November 21, 2002

RE: St. Lucie Units 1 and 2
Docket Nos. 50-335 and 50-389
Reactor Pressure Vessel Head (RPVH) Inspection
NRC Bulletin 2002-02 Supplemental Response

**NRC Bulletin 2002-02
Reactor Pressure Vessel Head and Vessel Head Penetration Nozzle
Post Inspection Response for St. Lucie Unit 1**

Figure 1: Typical UT Scan Showing Lack of Coverage Area in the Nozzle Material Adjacent to the Weld.

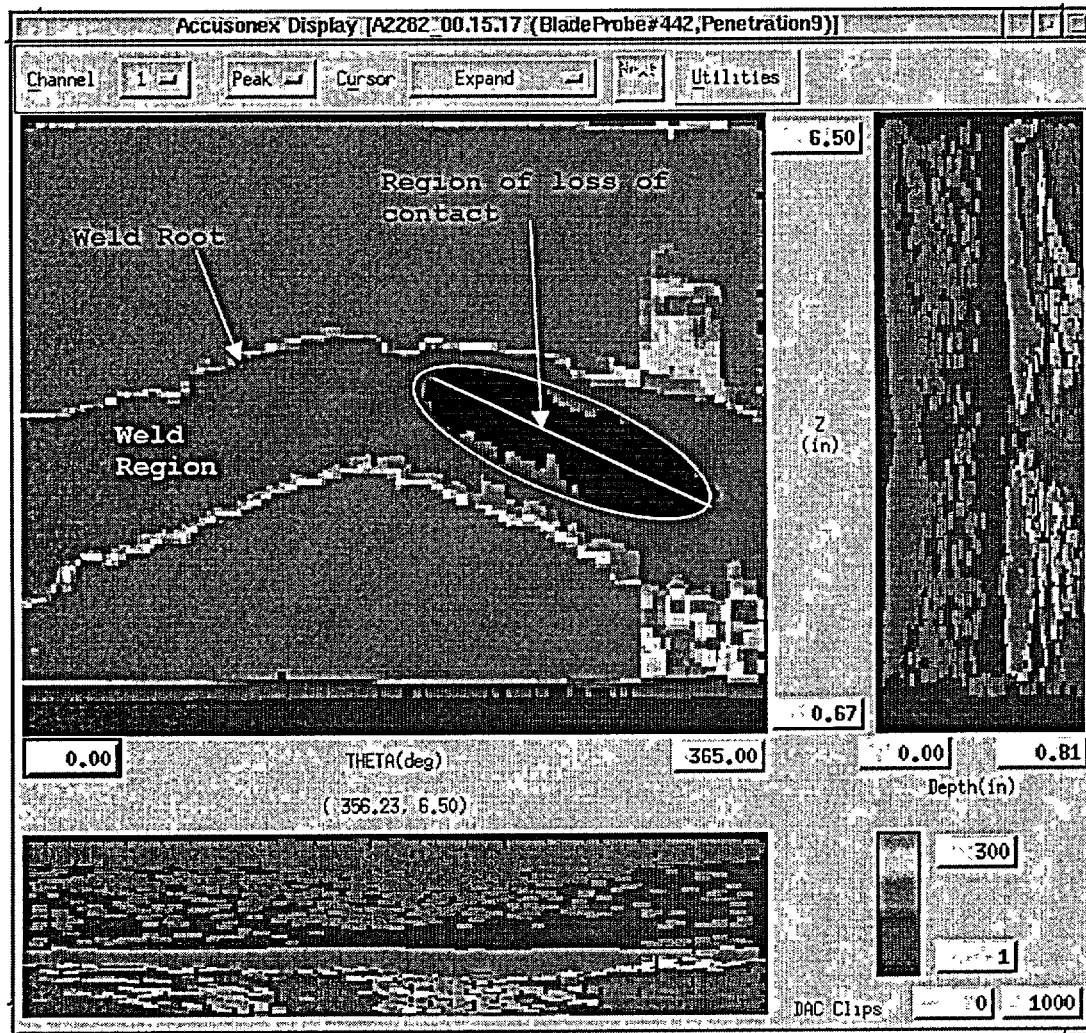
2.D. UT Inspection Coverage Limitations: Many of the RVHPs have identified areas of limited coverage due to issues related to maintaining surface contact between the blade UT probe and the penetration surface (lift off). The regions of limited coverage have been localized primarily to the weld region and/or the nozzle material below the weld and are generally located on the downhill side of the nozzle penetration. Figure 1 is an illustration of the coverage obtained for a typical nozzle examination. Contact between the probe and examination surface is affected by the gap between the guide sleeve and the nozzle penetration ID surface, and by the delivery method of the blade UT probe into the gap. The blade UT probe is delivered into the gap between the guide sleeve and the nozzle penetration by flexing the probe around the guide funnel that is in close proximity to the CEDM penetration. Figure 2 is an illustration of the double bend path of the UT blade probe. The blade probe is designed to fit a nominal gap size and has compliance built in for slight variations in the sleeve centering. This compliance allows for the probe to be inserted into a range of gap sizes to compensate for guide sleeve positioning. However, if the guide sleeve is offset to one side of the nozzle and provides a gap that exceeds the tolerance of the probe compliance, contact with the examination surface will not be maintained. Normal weld shrinkage stresses at the nozzle ID surface in the weld region adds to the surface contact issue. The combination of these conditions and the double bend path explains the lift off encountered at the lower portion of the nozzle and the excellent UT coverage at the weld root and above.

A review of the areas of loss of inspection coverage to evaluate its significance was performed. The inspection coverage was separated into four distinct regions for evaluation. Those regions include the area above the weld root, the area at/adjacent to the root, the nozzle area adjacent to the weld, and the area below the weld. A matrix of the UT inspection weld coverage is shown in Table 2.

Figure 2: UT Blade Probe Path to Inspect the St. Lucie Unit 1 CEDM
(Dimensions are in inches)

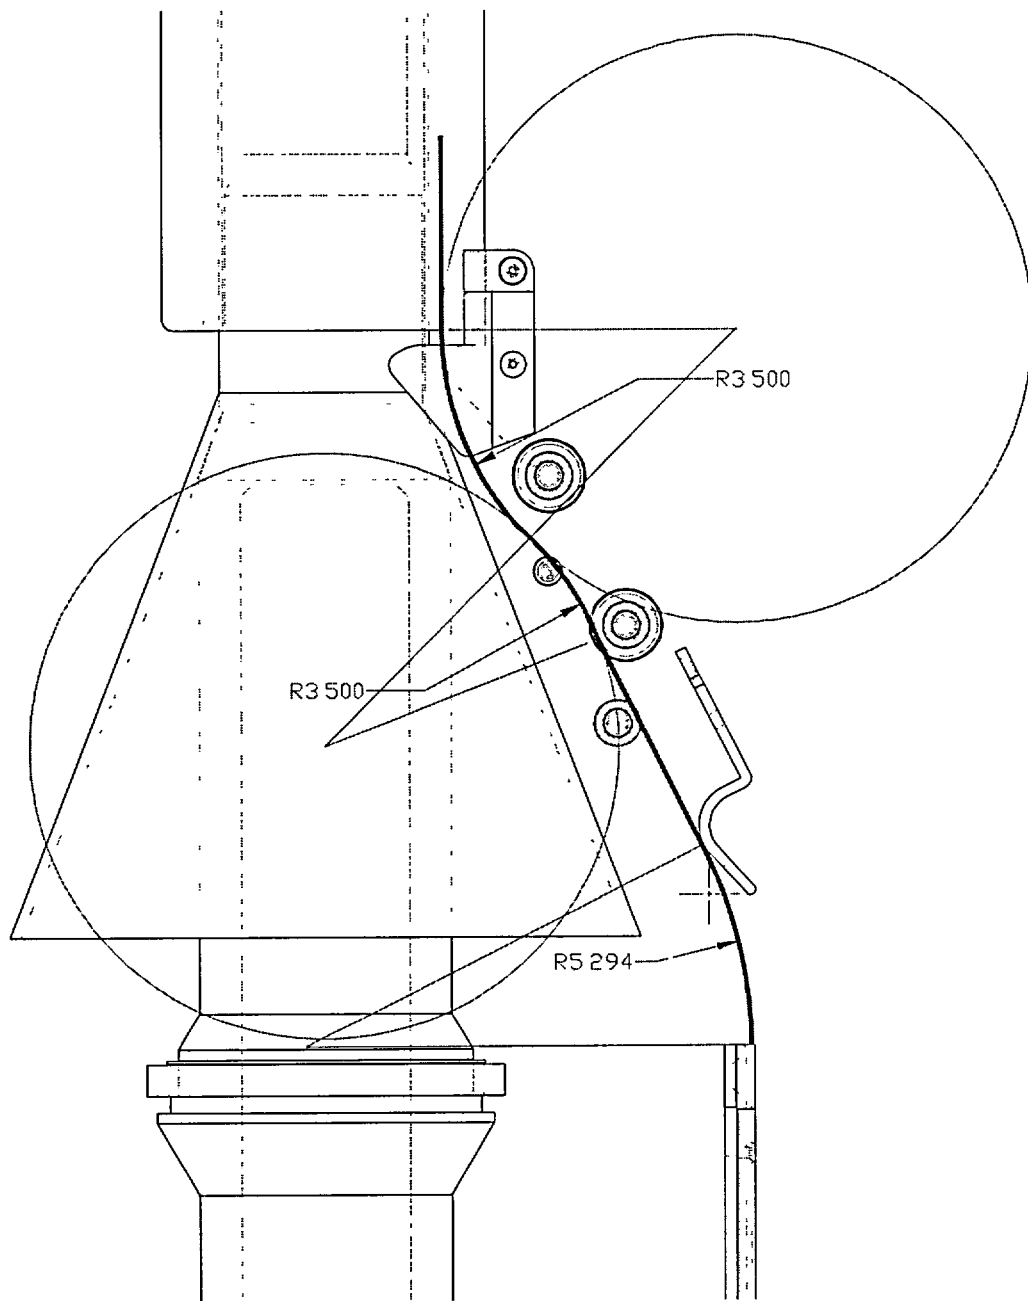
The guide sleeves cannot be moved to adjust the gap between the sleeve and the nozzle penetration. Initially, additional scans were performed in an attempt to provide more coverage of the examination area. Also, slower probe speeds, additional couplant, and different probe designs were tried. The rescans were unsuccessful in providing additional coverage of the examination area. It is the inspection vendor's position that the data supplied is the best that could be provided using blade probes.

Figure 3: Crack Growth Predictions for an 85° Circumferential Through-Wall Flaw Near the Top of the Attachment Weld for CEDM Nozzles (This figure is based on Figure 6-21 from WCAP-15945-P with the MRP-55 factor of 2.0 included)

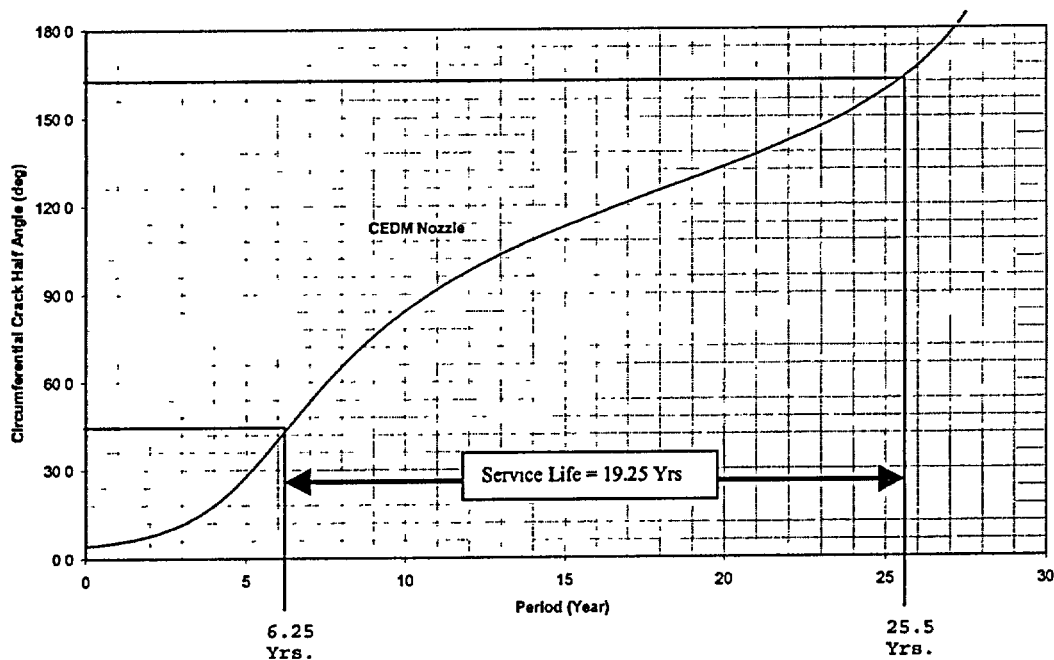
A flaw tolerance evaluation was performed postulating a circumferential flaw in the area of lack of coverage at the weld root and above using WCAP-15945-P². The flaw is assumed to be the maximum circumferential length of the area of lack of coverage (85°). Figure 3 shows the time required for the postulated 85° flaw to grow to a point of structural significance (330°) to be 19.25 years of operation. Figure 3 is plotted as half the length of the circumferential flaw to account for both ends of the flaw to grow equally. The evaluation uses plant specific stresses and operating temperature and the MRP-55³ crack growth rate predictions with a factor of two applied to account for

uncertainty. Based on the UT inspection results of no indications in the nozzle area examined at the weld root and above, and this evaluation, there are no concerns with the structural integrity of the RVHPs for over 19 years of operation. This conclusion postulates a circumferential crack in the missed coverage areas in the RVHP material at the weld root or above. The RVHPs will be reinspected with UT within 4 effective degradation years (EDY) not to exceed 10 EFPY and visually inspected at every refueling outage, based on the current MRP-75 recommended reinspection interval.

Figure 1

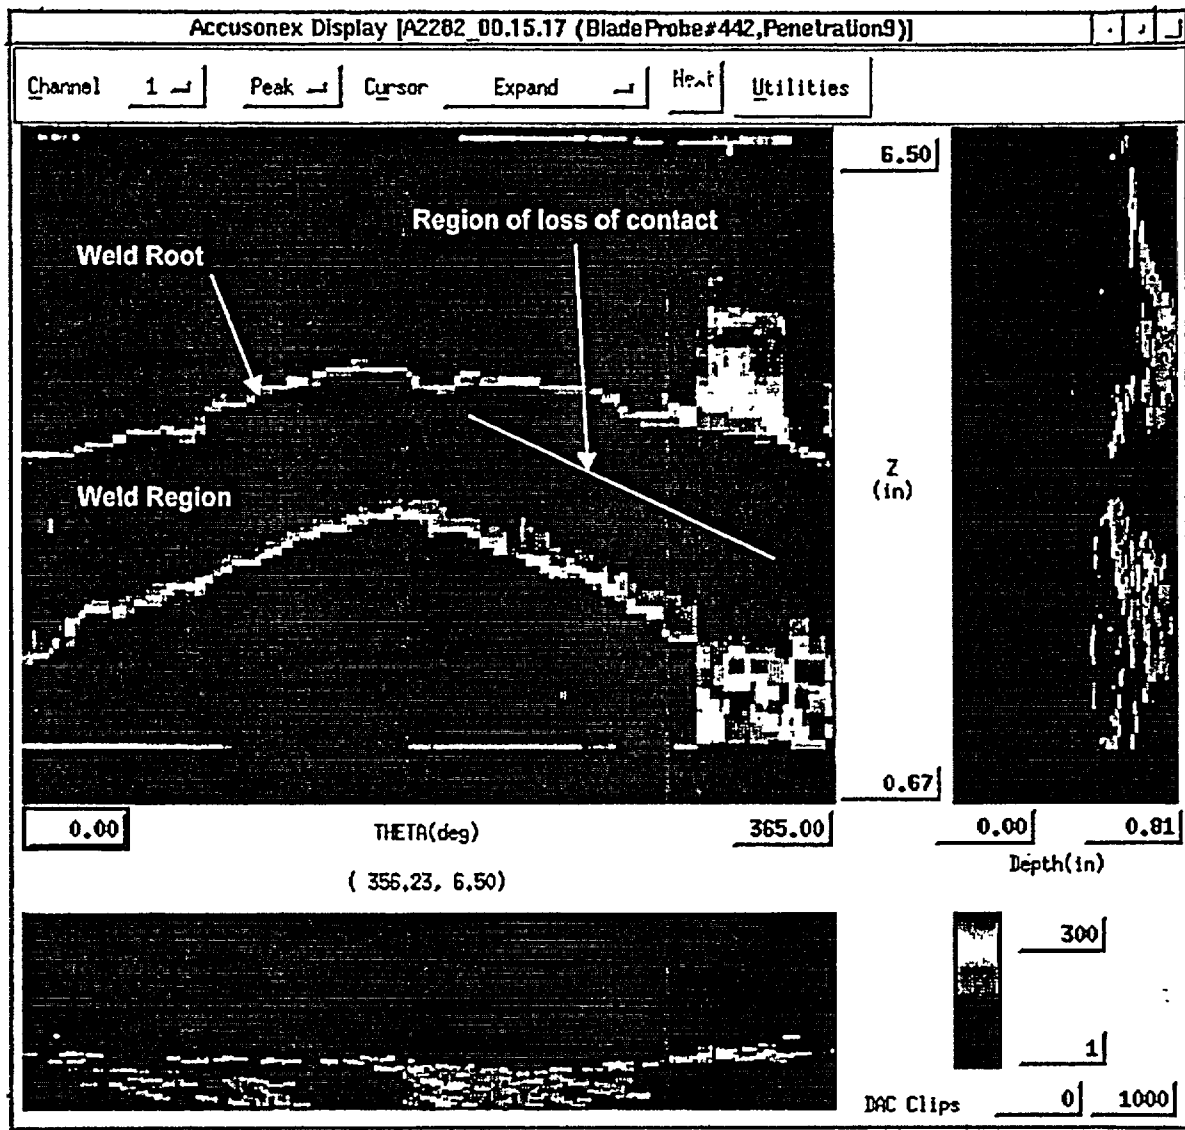
Most penetrations have identified areas of limited coverage due to issues related to maintaining surface contact between the UT probe and the penetration surface. The regions of limited coverage have been localized primarily to the weld region and/or the nozzle material below the weld and are generally located on the downhill side of the nozzle penetration. Refer to Figure 1 for an illustration of the coverage obtained for a typical nozzle examination. Contact between the

Figure 3

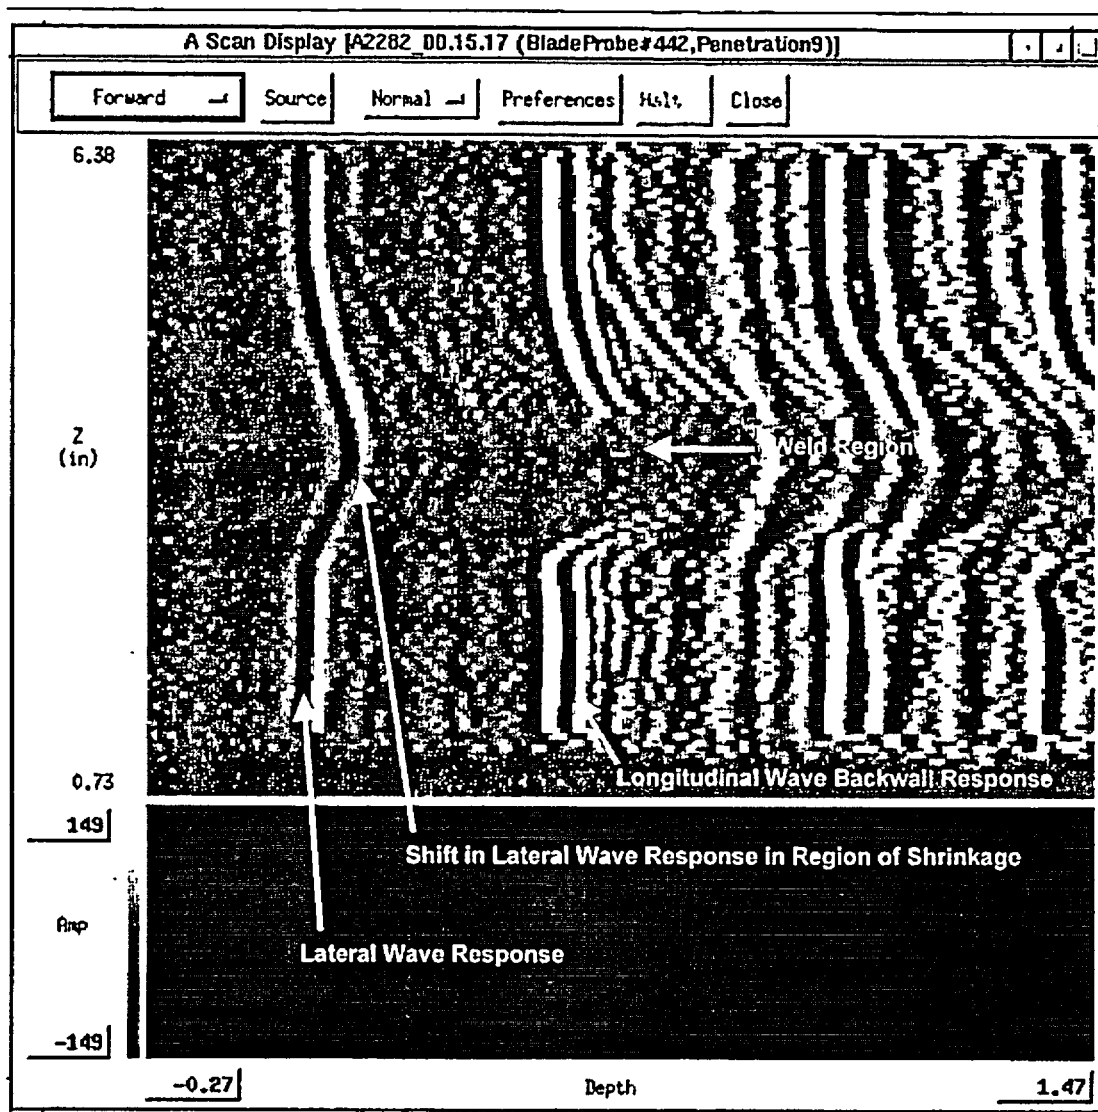
probe and examination surface is affected by the gap between the guide sleeve and the nozzle penetration ID surface, and by the delivery method of the blade UT probe into the gap. The UT probe is delivered into the gap between the guide sleeve and the nozzle penetration by flexing the probe around the guide funnel that is in close proximity to the CEDM penetration. See Figure 2 below for an illustration of the insertion of the blade probe. The blade probe is designed to fit a nominal gap size and has compliance built in for slight variations in the sleeve centering. This compliance allows for the probe to be inserted into a range of gap sizes to compensate for guide sleeve positioning. However, if the guide sleeve is offset to one side of the nozzle that provides a gap that exceeds the tolerance of the probe compliance, contact with the examination surface will not be maintained. Shrinkage of the nozzle ID surface in the weld region due to welding adds to the surface contact issue. The nozzle penetrations examined at St. Lucie Unit 1 have exhibited evidence of shrinkage at the nozzle ID surface in the weld region; refer to Figure 3 for an example of the effects of the shrinkage for maintaining contact.

The guide sleeves cannot be moved to adjust the gap between the sleeve and the nozzle penetration. Additional scans have been performed in an attempt to provide more coverage of the examination area. Slower probe speeds, addition of more couplant and use of different probes were tried. The rescans were unsuccessful in providing additional coverage of the examination area. It is Framatome's position that the data supplied is the best that could be provided using blade probes.
